RE: SKYLAND HILLS MOBILE HOME PARK  
STARK COUNTY  
3IY00161 \*BD

On June 22, 2009, this writer conducted a compliance evaluation inspection (CEI) of the treatment system which serves your water treatment plant. The treatment system consists of surface sand filters and a tablet dechlorinator.

Surface sand filter beds.

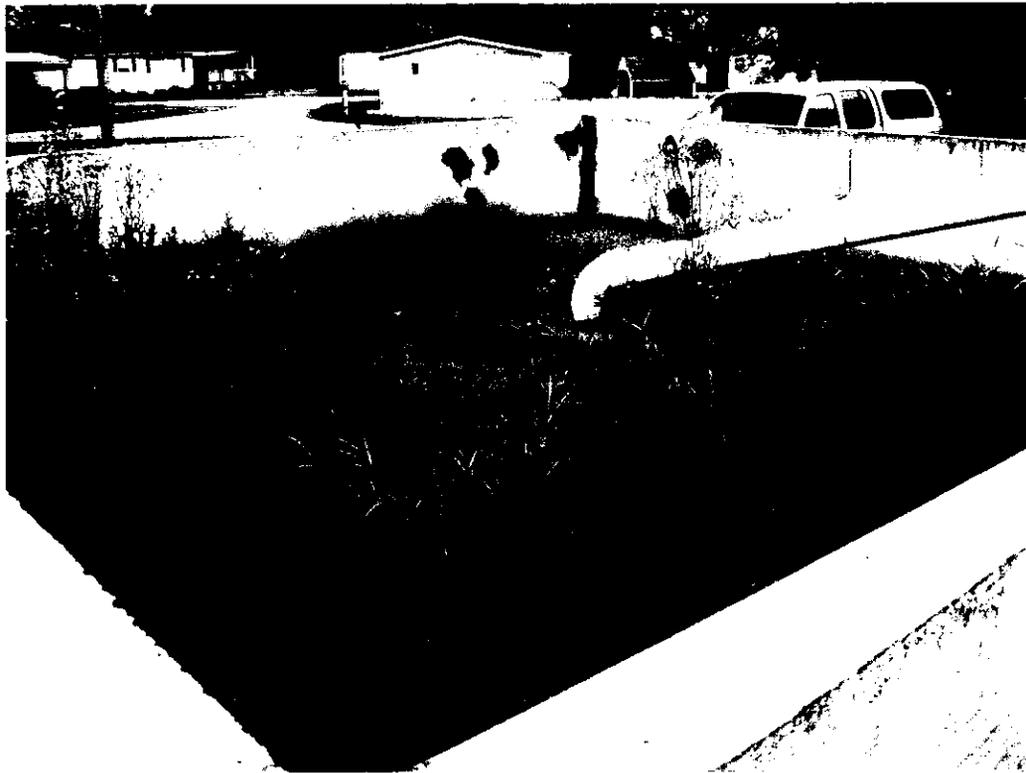
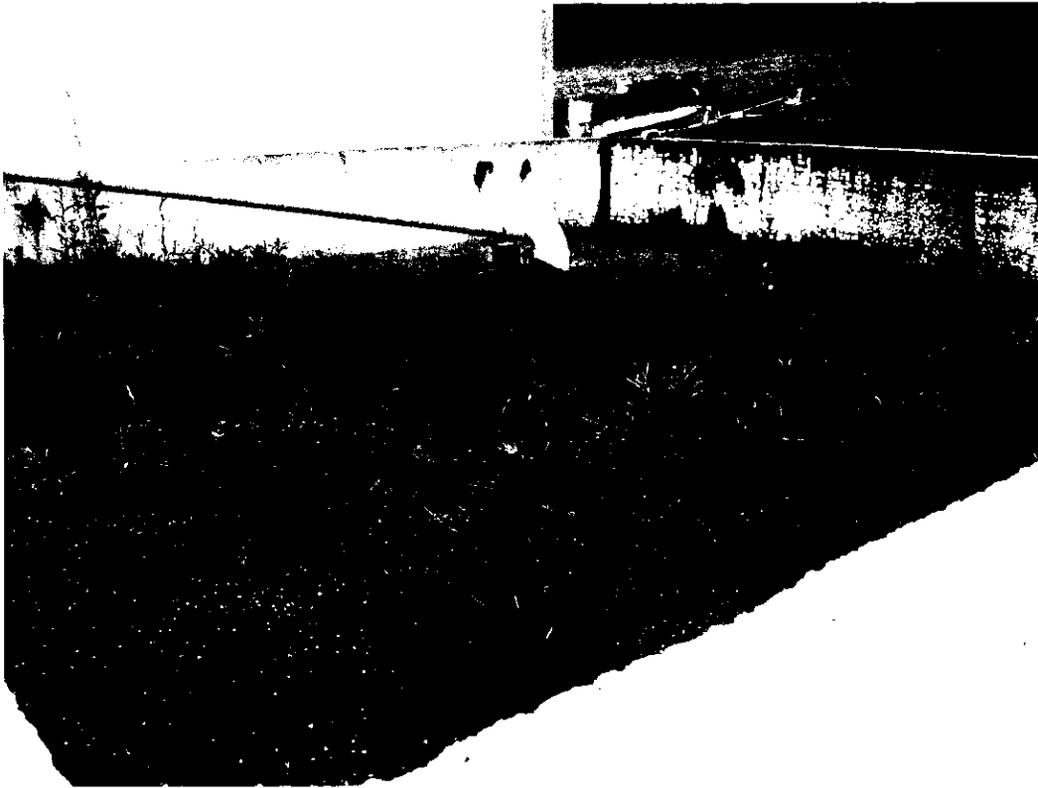
At the time of the inspection, the sand filter beds contained excessive vegetation which needs to be removed. The tablet dechlorinator did not contain any dechlorination tablets.

Please respond to this office, in writing, when the above deficiencies have been corrected.
